Access Compliance Report Public Rights-of-Way (Pedestrian Signals)

Main Street: MCFADDEN_AVE Cross Street: BEACH_BLVD Location: NW

ADA ID: SGRK211005144708 Signal Type: One Push Button-APS Overall Compliance: No Severity Scores: BTN 1: 25 BTN 2: N/A No BTN: N/A

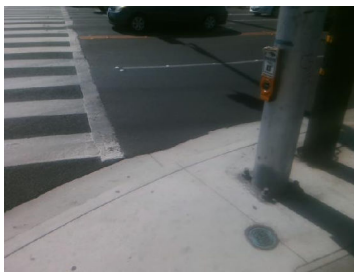
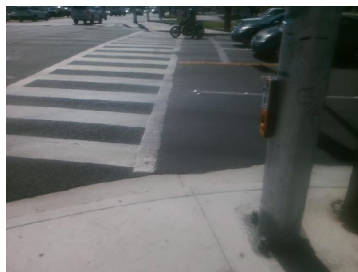
Possible Solutions: Remove and Replace Clear Space.

OC Std/PROW: R404.2, R404.3
